Access Compliance Report

Public Rights-of-Way

Intersection ID: 30419	Main Street: ELM_BEND_DR	Cross Street: FENWAY_DR	Location: NE
ADA ID: 38BEC942D212	Ramp Type: Perp	Initial Pass/Fail: Fail	Overall Compliance: No
			Severity Score: 21.25

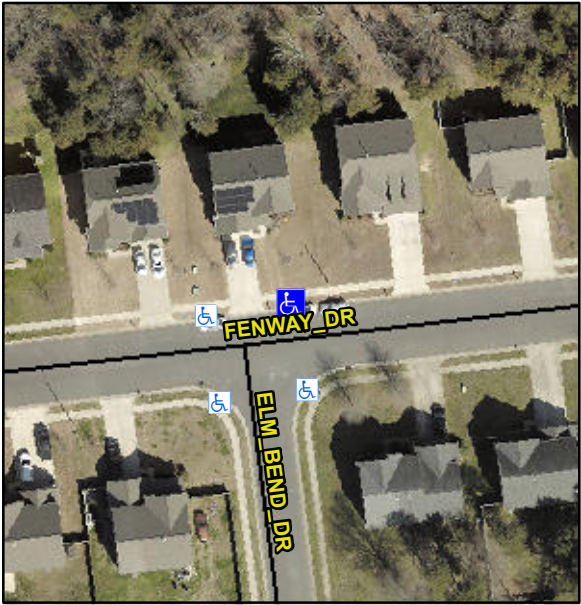
Codes/Mitigation Info/Possible Solution		Field Measurements/Component Compliance					
	Possible Solutions:	Compliance	Description	Data	Compliance	Description	Data
	Remove & Replace Entire Ramp.	N/A	Ramp Length (in)	47.0	No	Ramp Slope (%)	8.7
		No	Ramp Width (in)	47.0	Yes	Ramp XSlope (%)	1.5
		N/A	Flare Type LT	N/A	N/A	Flare Type RT	N/A
		N/A	Flare Slope LT (%)	N/A	N/A	Flare Slope RT (%)	N/A
		N/A	Flare Traversable LT?	N/A	N/A	Flare Traversable RT?	N/A
		N/A	Landing Length (in)	N/A	N/A	DWS Provided?	N/A
		N/A	Landing Width (in)	N/A	N/A	DWS Contrast?	N/A
		N/A	Landing Slope (%)	N/A	N/A	DWS Length (in)	N/A
		N/A	Landing X Slope (%)	N/A	N/A	DWS Full Width?	N/A
		N/A	Landing Curb? (Y/N)	N/A	N/A	DWS Offset (in)	N/A
		N/A	Shared Landing?	N/A			
		N/A	Gutter Ponding?	N/A	N/A	Gutter Slope (%)	N/A
		N/A	Gutter Lip Ht (in)	N/A	N/A	Gutter X Slope (%)	N/A
		N/A	Painted X Walk1?	No	N/A	Painted X Walk2?	N/A
			X Walk 1 Direction	To S		X Walk 2 Direction	N/A

N/A	X Walk 1 Width (in)	N/A	N/A	X Walk 2 Width (in)	N/A
			X Walk 1 Slope (%)	2.0		X Walk 2 Slope (%)	N/A
			X Walk 1 X Slope (%)	0.5		X Walk 2 X Slope (%)	N/A
		N/A	Ramp inside XWalk1?	N/A	N/A	Ramp inside XWalk2?	N/A
<p>Surveyor Notes:</p> <p>N/A</p> <p>PROW/ADA:</p> <p>R304.5.1, R304.2.2</p>			Road Slope (%)	N/A	N/A	Clear Space?	N/A
			Road X Slope (%)	N/A	N/A	Clear Space to XWalk (in)	N/A
		N/A	Any Obstructions?	N/A	N/A	Storm Grate/Utility Hazard?	N/A
			Obstruction Type			Storm Grate/Utility Type	
					N/A		N/A
					Yes	Surface Condition? (G/P)	Good
